- **TMC246A-PA**
- **TMC246A-PA-T**
- **TMC246A-PA-X**

Product Change Notification

PCN-2016-06-02

Figure 1: TMC246 block diagram

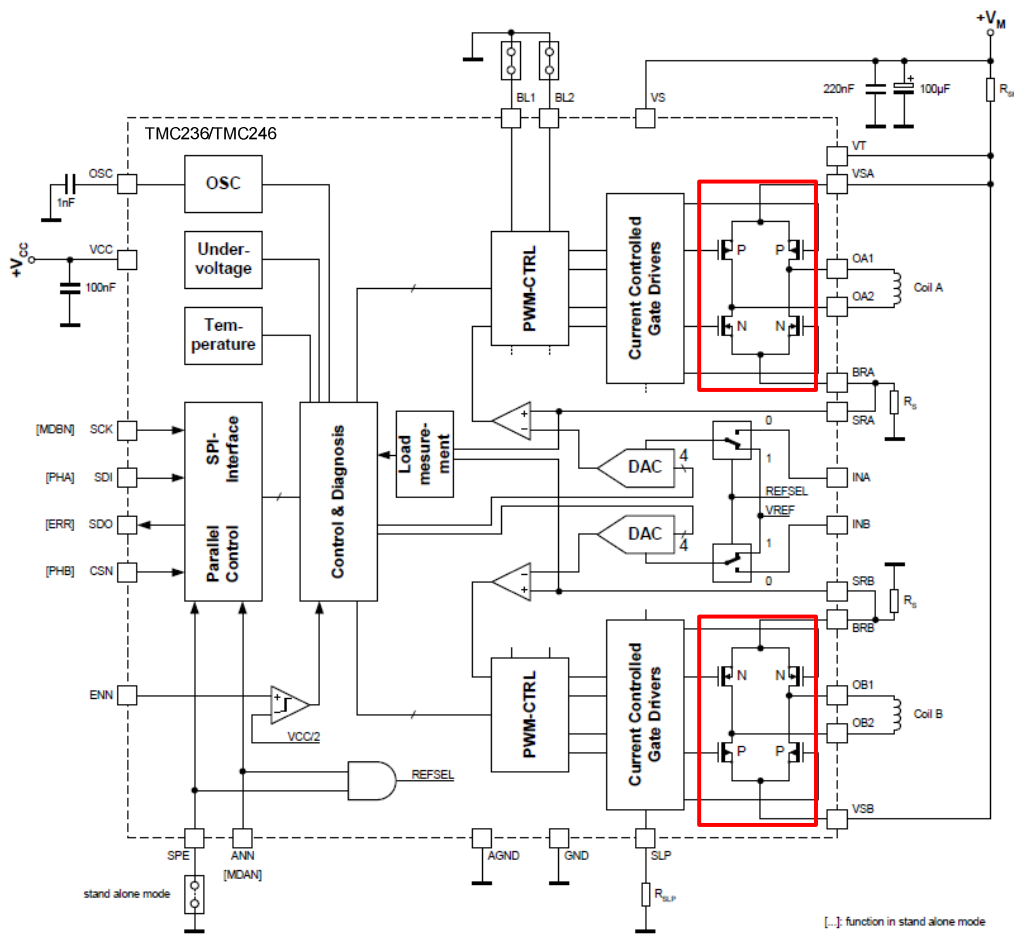
Due to product maintenance and to assure longevity of the TMC246 we qualified a new wafer fab for TMC246 motor driver MOSFETs full-bridges. Hardware changes:

- Motor driver N-channel MOSFET (4pcs. in total)
- Motor driver P-channel MOSFET (4pcs. in total)
- Revision field of IC label will change from "A" to "B". (TMC246A to TMC246B)
- New motor driver MOSFETs will improve power losses due to lower R_{dson}

You can find the relevant MOSFETs (red marked) in the block diagram in figure 1. Due to the multi-chip structure of the TMC246 only motor driver MOSFET dies are affected to the changes. Complete digital and analog part of the core die as well as lead frame and IC structure stays unchanged.
